Access Compliance Report Public Rights-of-Way (Curb Ramps)

Main Street: WALLINGSFORD_RD Cross Street: QUAIL_RUN_RD Location: SW

ADA ID: RPRK220218140743 Ramp Type: Type 1 - Perpendicular Diagonal Initial Pass/Fail: Pass Overall Compliance: No Severity Score: 10

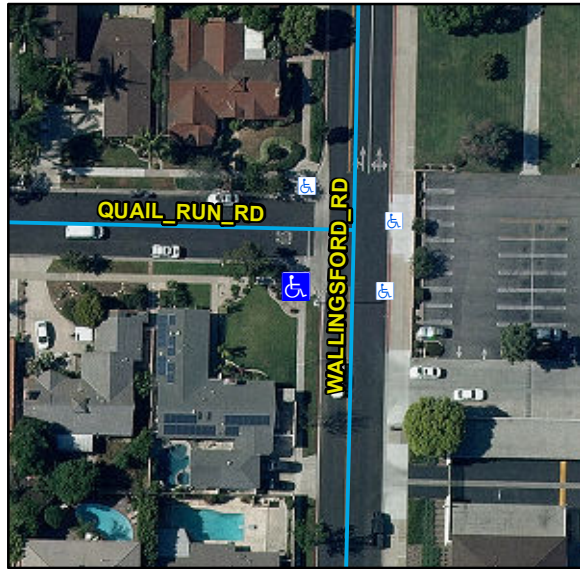
R304.2.2-Perp, R304.3.2-Para, R305, STD 1115

Remove & Replace Curb Ramp With Two New Directional Ramps or Equivalent.
